Well Name	Well Number	US Well Number	Lease Number	Case Number	Operator
STRAY CAT 8-5	803H	3002551255	NMNM98826	NMNM98826	DEVON
STRAY CAT 8-5	603H	3002551257	NMNM98826	NMNM98826	DEVON
STRAY CAT 8-5	703H	3002551259	NMNM98826	NMNM98826	DEVON

Notice of Intent

Type of Action: Variance

Procedure Description: Devon Energy Production Co., L.P. (Devon) respectfully requests a variance to break test.

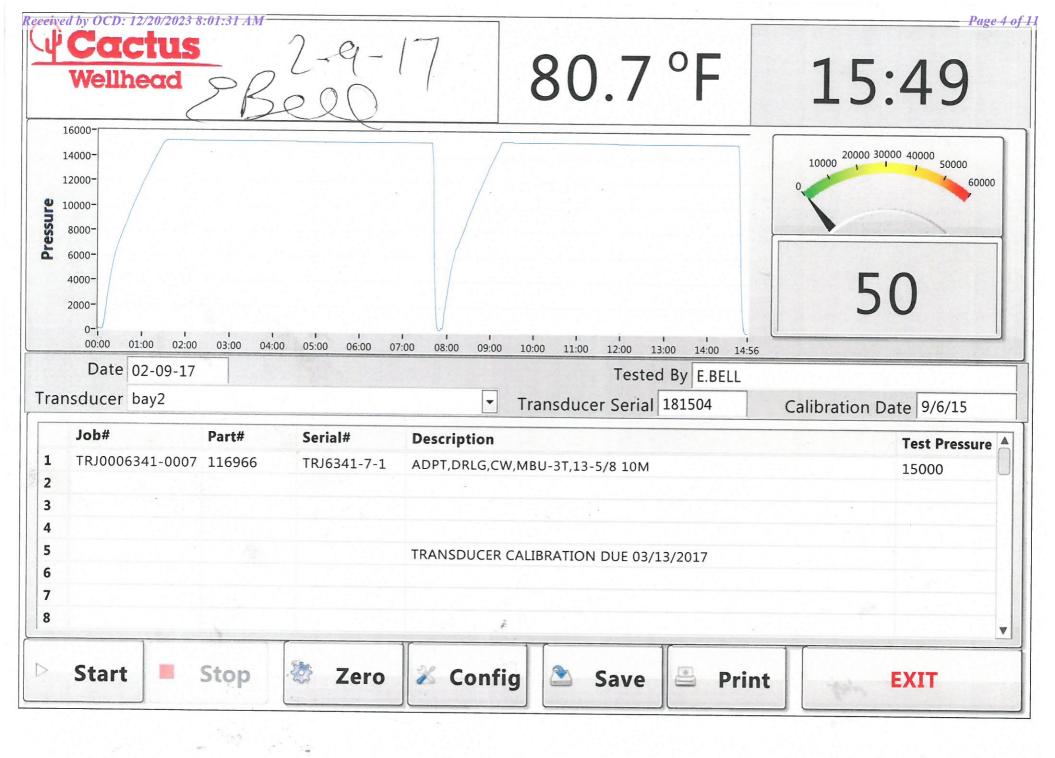
Devon Energy requests to only test BOP connection breaks after drilling out of surface casing and while skidding between wells which conforms to API Standard 53 and industry standards. This test will include the Top Pipe Rams, HCR, Kill Line Check Valve, QDC (quick disconnect to wellhead) and Shell of the 10M BOPE to 5M for 10 minutes. If a break to the flex hose that runs to the choke manifold is required due to repositioning from a skid, the HCR will remain open during the shell test to include that additional break. The variance only pertains to intermediate hole-sections and no deeper than the Bone Springs Formation where 5M BOP tests are required. The initial BOP test will follow OOGO2.III.A.2.i, and subsequent tests following a skid will only test connections that are broken. The annular preventer will be tested to 100% working pressure. This variance will meet or exceed OOGO2.III.A.2.i per the following: Devon Energy will perform a full BOP test per OOGO2.III.A.2.i before drilling out of the intermediate casing string(s) and starting the production hole, before starting any hole section that requires a 10M test, before the expiration of the allotted 14-days for 5M intermediate batch drilling or when the drilling rig is fully mobilized to a new well pad, whichever is sooner. We will utilize a 200' TVD tolerance between intermediate shoes as the cutoff for a full BOP test. The BLM will be contacted 4hrs prior to a BOPE test. The BLM will be notified if and when a well control event is encountered. Break test will be a 14 day interval and not a 30 day full BOPE test interval. If in the event break testing is not utilized, then a full BOPE test would be conducted.

- 1. Well Control Response:
- 1. Primary barrier remains fluid
- 2. In the event of an influx due to being underbalanced and after a realized gain or flow, the order of closing BOPE is as follows:
 - a) Annular first
 - b) If annular were to not hold, Upper pipe rams second (which were tested on the skid BOP test)
 - c) If the Upper Pipe Rams were to not hold, Lower Pipe Rams would be third

All Previous COAs Still Apply. Variance request procedure is approved as written, please see below general conditions for variance.

- BOPE Break Testing is ONLY permitted for 5M BOPE or less. (Annular preventer must be tested to a minimum of 70% of BOPE working pressure and shall be higher than the MASP)

- BOPE Break Testing is NOT permitted to drilling the production hole section.
- Variance only pertains to the intermediate hole-sections and no deeper than the Bone Springs formation.

- A full BOPE test is required prior to drilling the first deep intermediate hole section. If any subsequent hole interval is deeper than the first, a full BOPE test will be required. (200' TVD tolerance between intermediate shoes is allowable).
